SITE PLAN REVIEW & PARCEL MAP APPLICATION FOR DAVITA DIALYSIS CENTER – APPROVED BY PLANNING COMMISSION

SITE PLAN REVIEW APPLICATION FOR POPEYE'S – APPROVED BY PLANNING DIRECTOR

SITE PLAN REVIEW OF LEMOORE AUTO WRECKING – APPROVED BY PLANNING DIRECTOR

Elevations Approved by Planning Commission

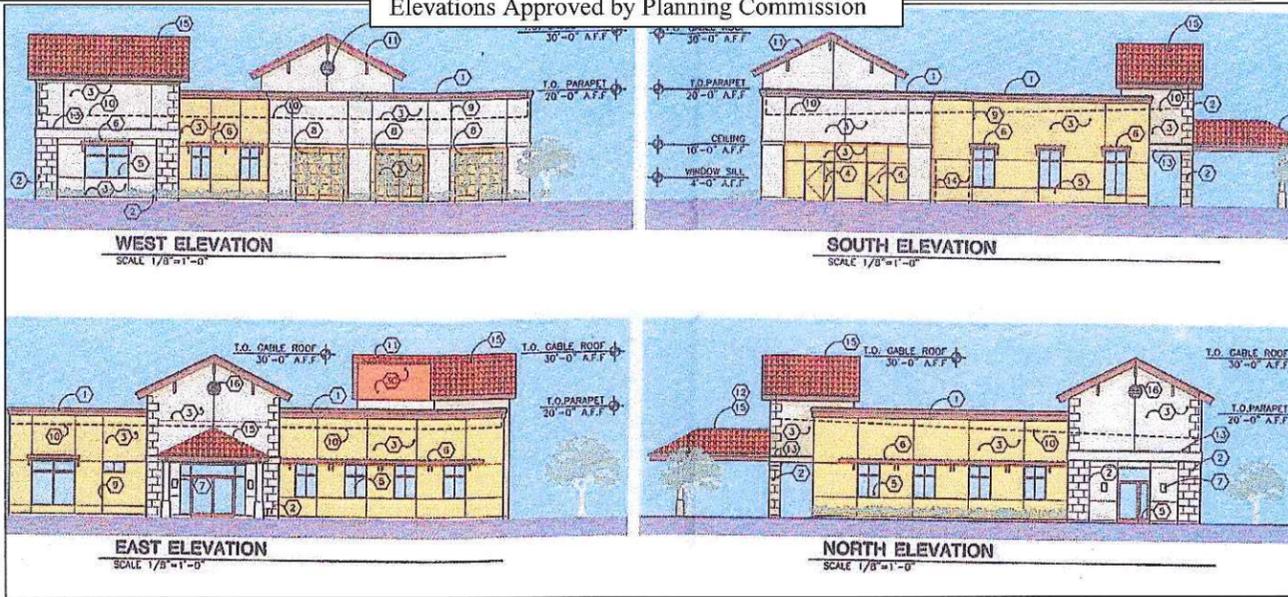
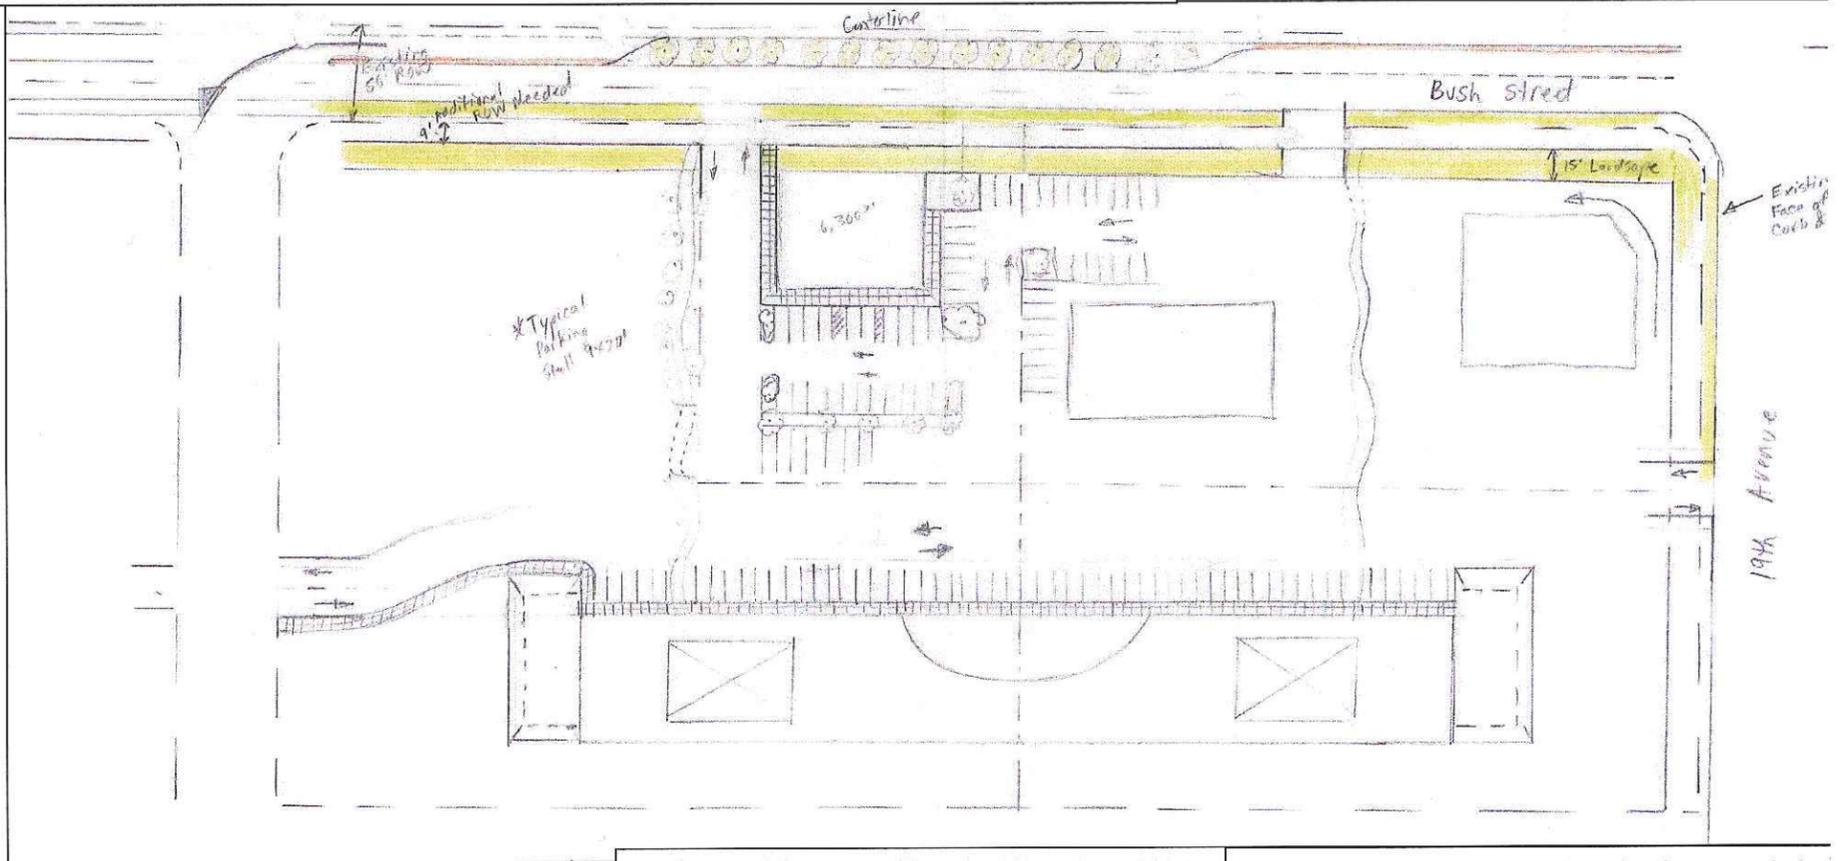
- 6,300 square foot building
- Site Plan Review could have been done administratively by staff if Parcel Map not involved
- General Plan (GP) policy CD-I-34 “require(s) design of building in neighborhood centers to be consistent with Lemoore’s small town character” and further addresses style, color, height, and landscape that should be incorporated.
- GP policy CD-I-36 “required continuous street frontage” with “no building setback from street unless a canopy or roof structure provided to maintain continuous sidewalk” as well as incorporating “centrally-located pedestrian access” which was accomplished with a pedestrian trellis versus building next to landscape buffer area shown on the Site Plans below
- Building canopy was not required by Planning but was part of Building Code for the type of use

Site specific Site Plan approved by Planning Commission

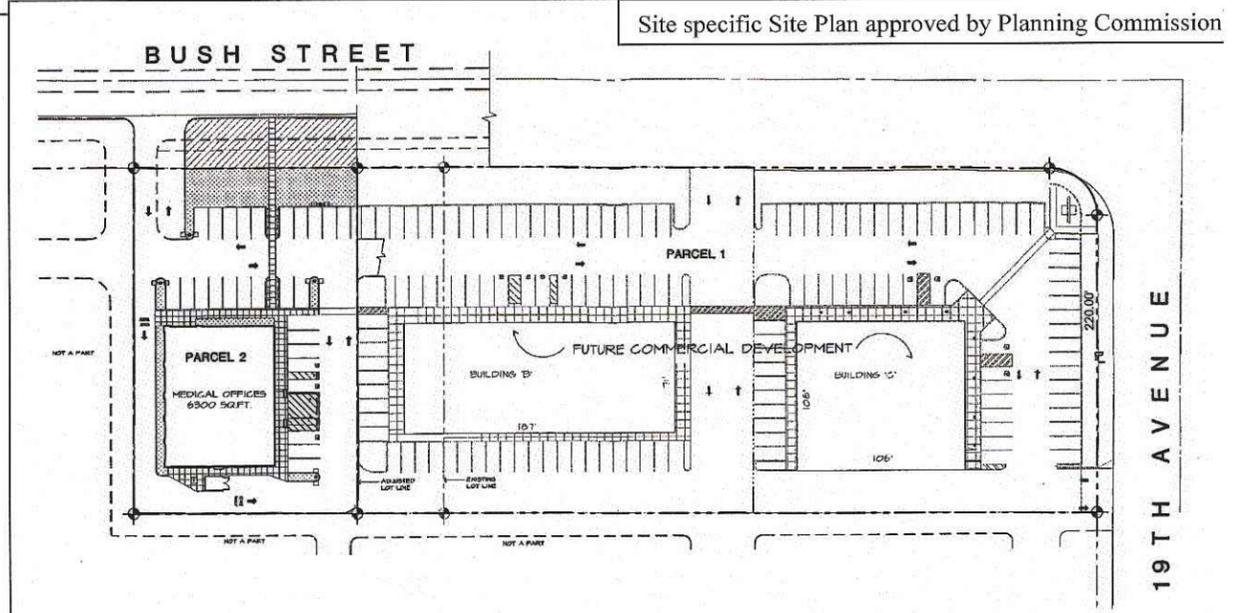
- Deferment allowed for median, paveout, bikelane, curb, gutter, parkway, and sidewalk as these improvements would be problematic in the near term across just this site. However, 8’ right-of-way dedication and 10’ public utility easements required to be given to the City prior to occupancy.
- GP goal C-G-4 states “maintain acceptable levels of service and ensure that future development and the circulation system are in balance.” This requires staff to review overall layout of entire shopping center to identify permanent long-term access points into the shopping center and ensure the flow within the shopping center will work in future years with the proposed near-term development.
- Flexible conditions put in place to allow for “cross-access” for utilities if the developer could get from adjacent property owner to reduce the lineal footage of utilities and thereby the costs

Original Elevations with redlined approvals incorporated

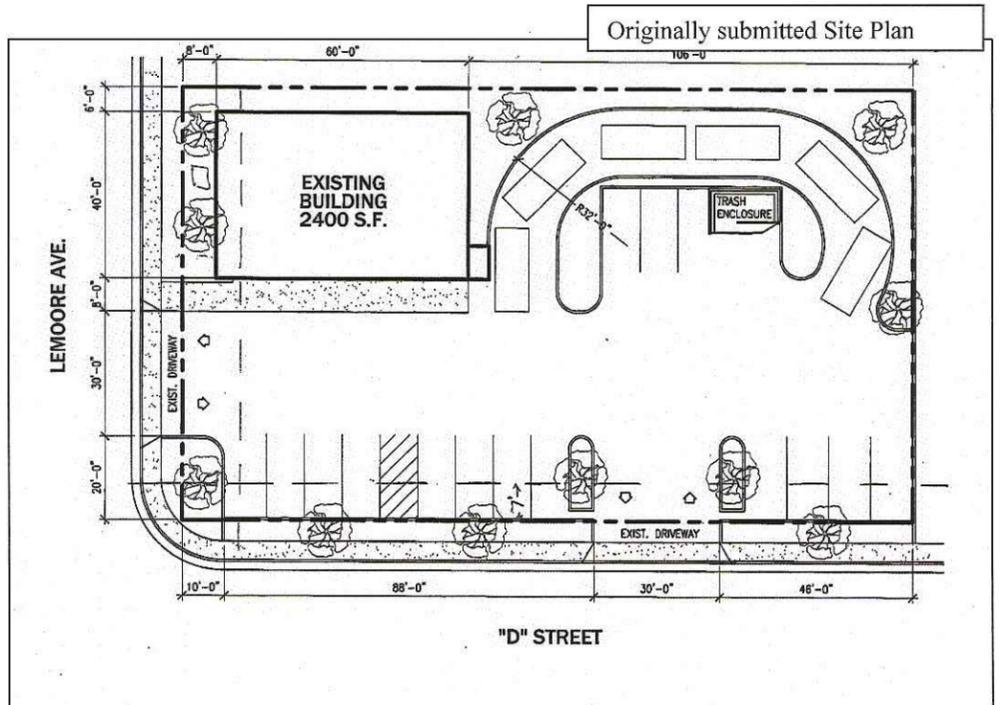
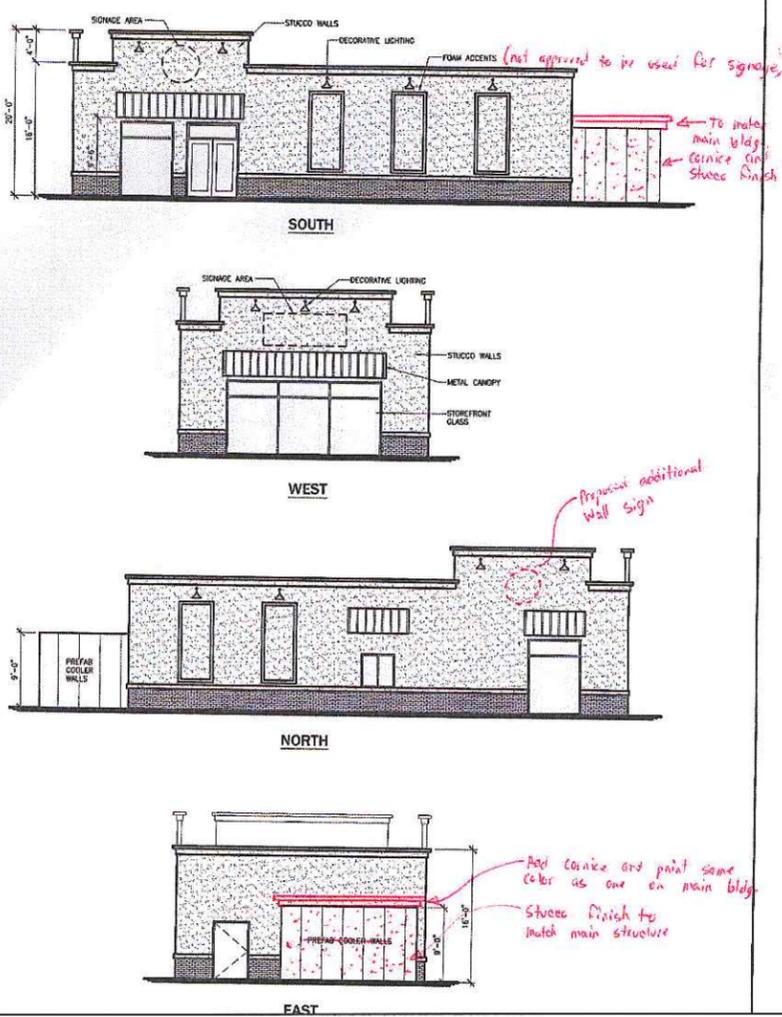
- General Plan goal CD-G-2 states "enhance key city entrances on primary vehicular corridors". Therefore trash enclosure that was going to be visible to incoming traffic enhanced to have a stucco coat over the blocks and add a cornice topper to match the main building structure.

Redlined Site Plan approved by Planning Director

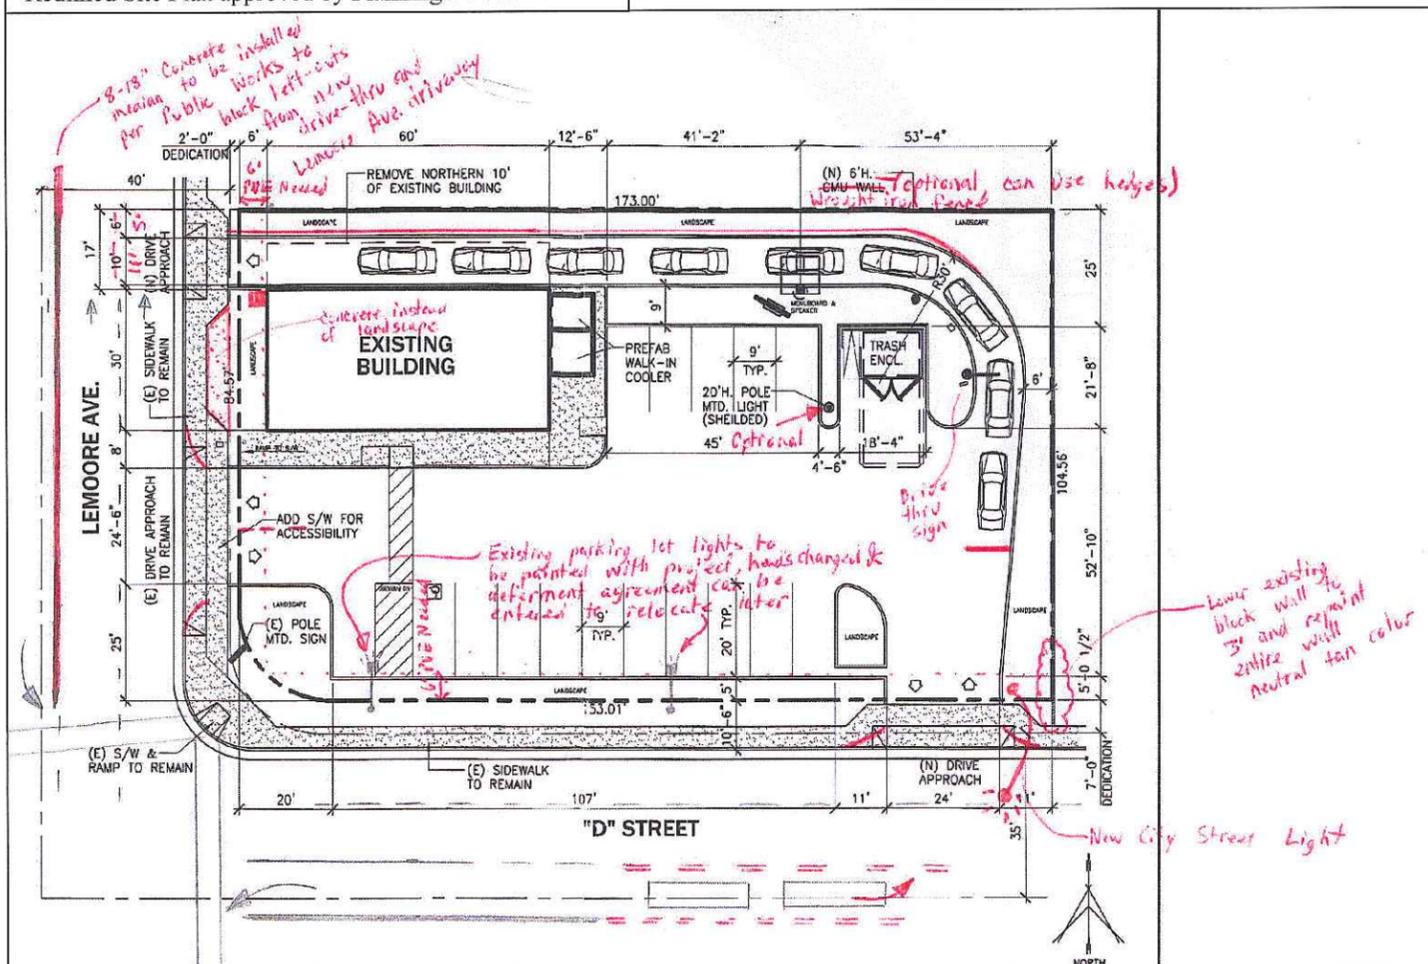
- Project involved converting 2,400 sq ft existing retail building (the old Auto Zone) into an 1,800 sq ft restaurant with drive-thru
- Original Site Plan layout fit less than 10 cars in the drive-thru with awkward layout that had potential to backup onto "D" Street westbound as well as eastbound turn pocket. Staff asked draftsman to configure to allow for at least ten car stacking based on problems experienced at other drive-thru locations. Resubmitted site plan with the back 10' of the building removed to accommodate utilities and drive thru lane for 10 car stacking on-site, and move the "D" Street driveway easterly to allow some stacking in turn pocket to allow left-turn into site.

- GP goal C-G-4 states "maintain acceptable levels of service and ensure that future development and the circulation system are in balance." GP policy C-I-1 states "adopt street standards that provide flexibility in design,....and revise right-of-way standards where necessary....some existing areas may require additional right-of-way to accommodate buildout traffic demand, or may be constrained by existing land use, which may limit the City's ability to meet the standards...". GP policy C-I-2 "requires(s) all new development to provide right-of-way improvements consistent with the General Plan street designations and street cross-section standards..." Previous traffic study done for St. Peters church project showed most of Lemoore Avenue needing to be channelized to reduce left-turn traffic movements (which generally means the installation of concrete or landscaped medians in heavy traffic conflict areas). Additionally, per General Plan Figure 4-4 shows "D" Street in front of the project as a future re-aligned Truck Route once adequate right-of-way is obtained. Median and right-of-way costs are not part of the impact fee program, nor do existing sites that are not adding additional building square footage subject to impact fees, therefore any traffic impacts caused by the "project" need to be addressed by the applicant directly.

- Based on the above policies and given the constraints adjacent to the site, right-of-way dedication of 7' along Lemoore Avenue and 2' along "D" Street prior to occupancy with existing monolithic sidewalks remaining but the improvements to the street will be handled with future City street widening projects which are included in the City's impact fee study. However, should the project cause traffic backups onto adjacent arterial streets in the future, the conditions of approval state the owner will need to resolve through one of many various options to keep initial project costs low. Concrete median required in Lemoore Avenue to avoid left-out from drive thru which would be a traffic hazard.

- General Plan policy CD-I-8 requires a 15-foot landscaped front setback area along all arterial and collector streets outside Downtown, as sites are developed or major renovations undertaken. 10' landscaping being incorporated in near term with future ability to remove 5' front portion of landscaping.

Original Elevations with redlined approvals incorporated

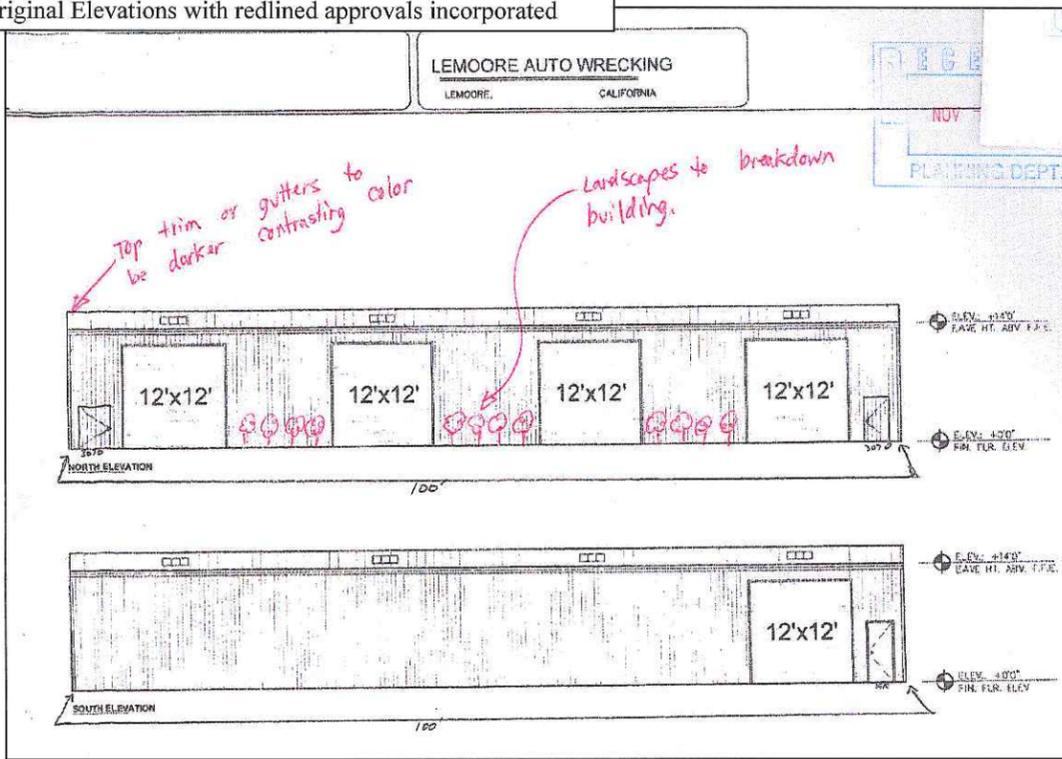
- General Plan (GP) policy CD-I-20 "ensure that non-residential building façades are visually attractive, with windows offering views into buildings and architectural articulation; prohibit large blank walls facing the street unless screened by landscaping. *These standards will be incorporated into the Zoning Ordinance and be applicable to all new development or major redevelopment along Iona Avenue.*". Therefore, landscaping added to northerly side of building foundation as well as westerly wall of building and colored top trim/gutter of the building to incorporate contrasting color.

Redlined Site Plan approved by Planning Director

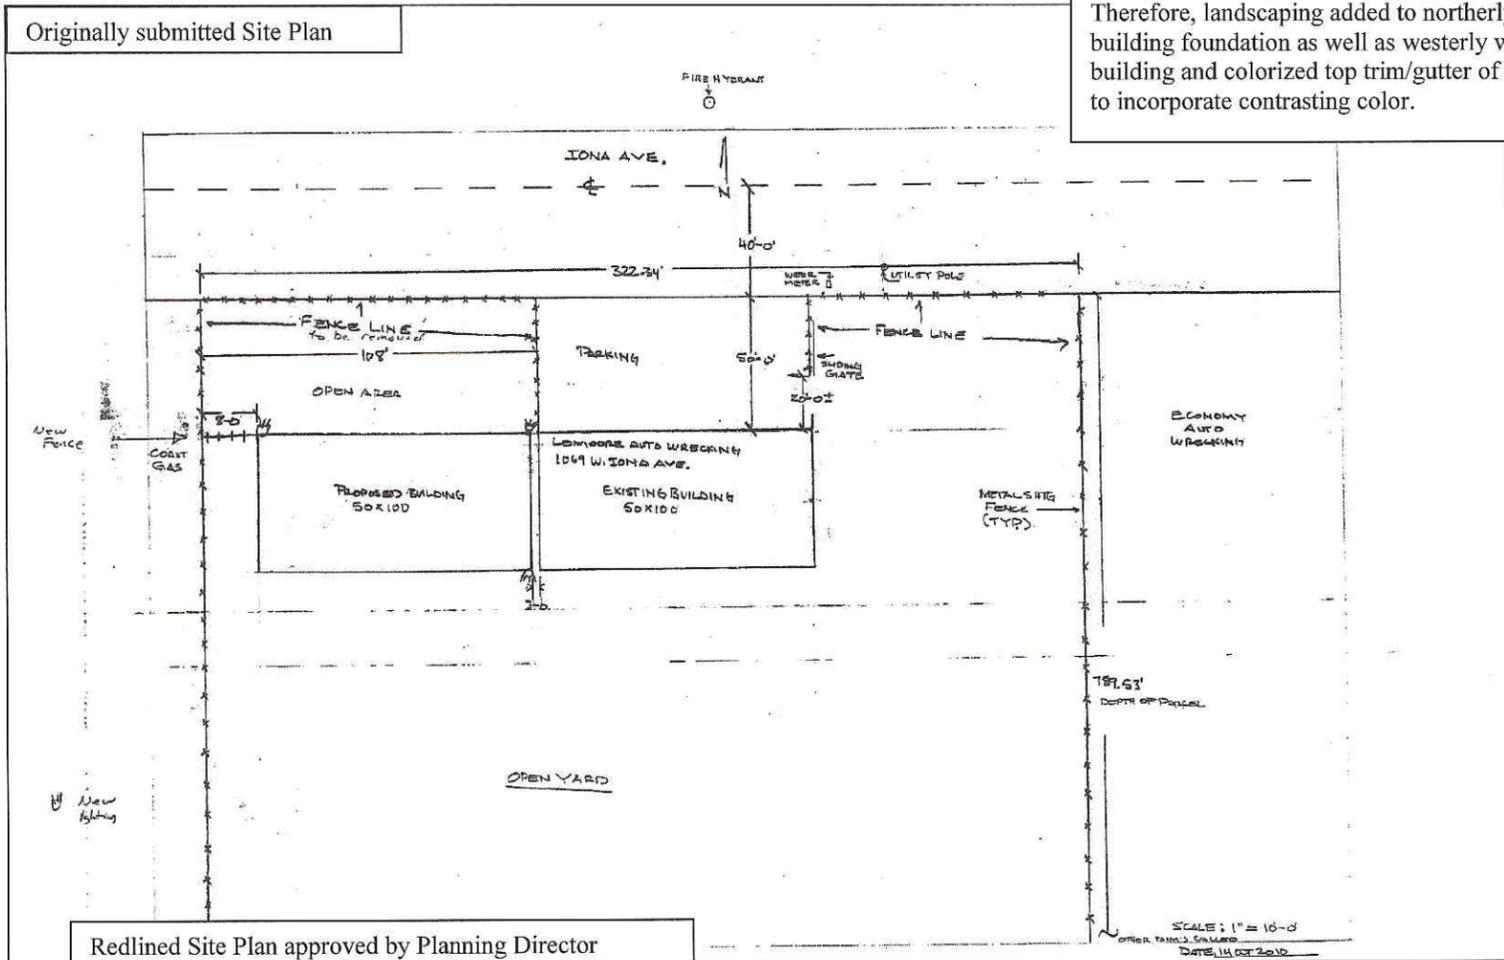
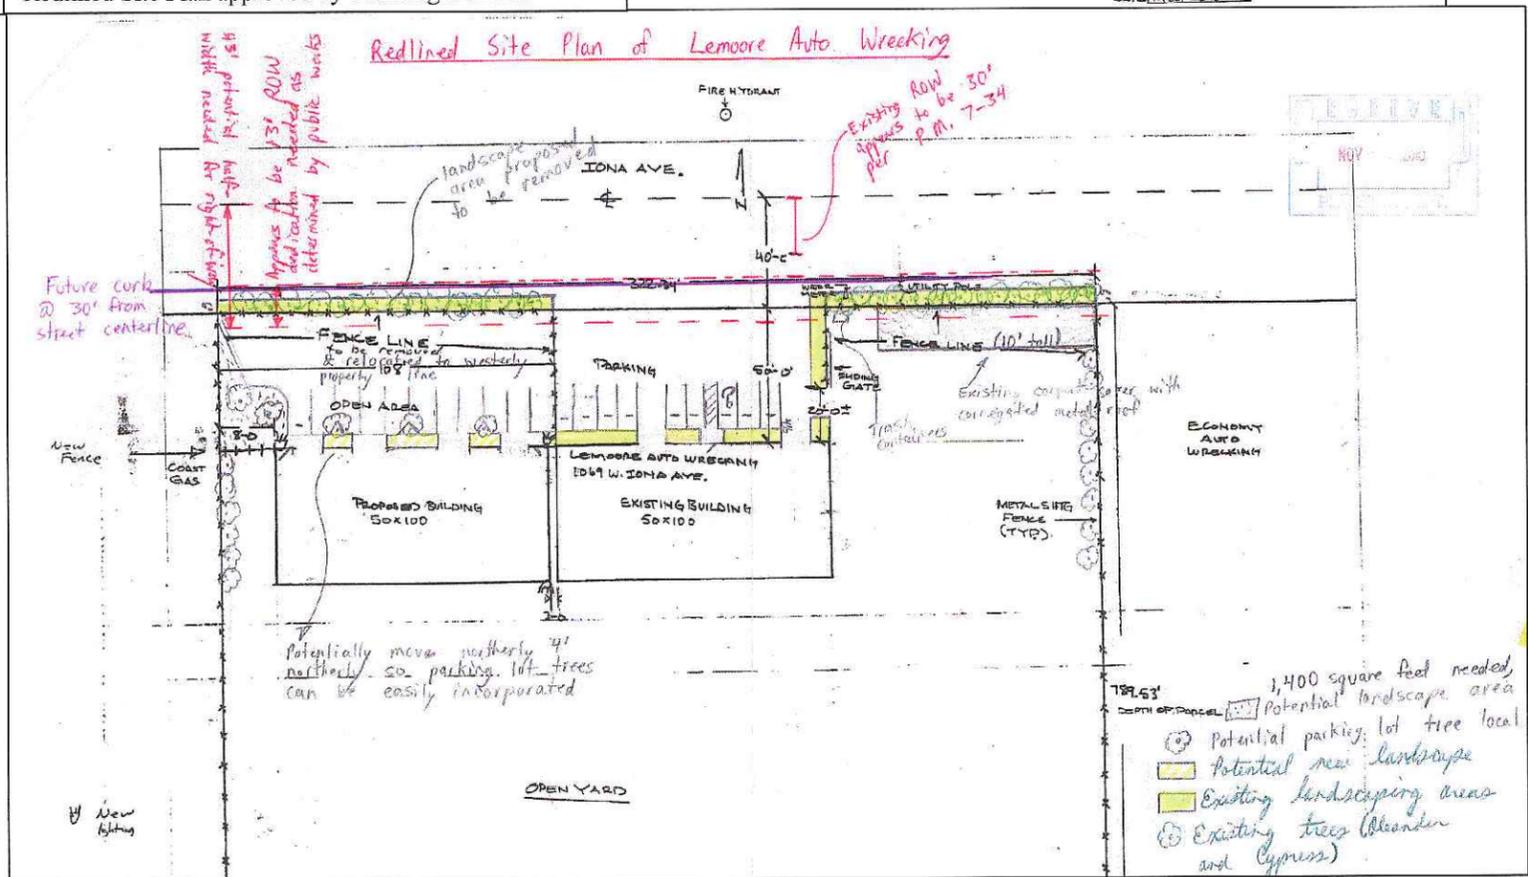
- Project involved the addition of a 5,000 sq ft storage building
- Original site plan didn't show all existing facilities, so staff went out to the site, took measurements and added information to base site plan to be complete versus giving back to applicant which would have significantly slowed down review (seems like the "smaller businesses" without draftsman/struggle with development process more than others)

- In reviewing GP figures 4-1, 4-2, 4-3, 4-4, 4-5 and Table 4.3 regarding street improvements along with GP policies CD-I-7, CD-I-40, and CD-I-42 for landscaping, the requirements were very unclear, so one condition allowed for City Engineer to further determine right-of-way up to a 13' dedication if needed, another condition allowed more time to finalize the specific landscaping so staff could have a study session with Planning Commission, allowed for the deferral of several street related improvements.
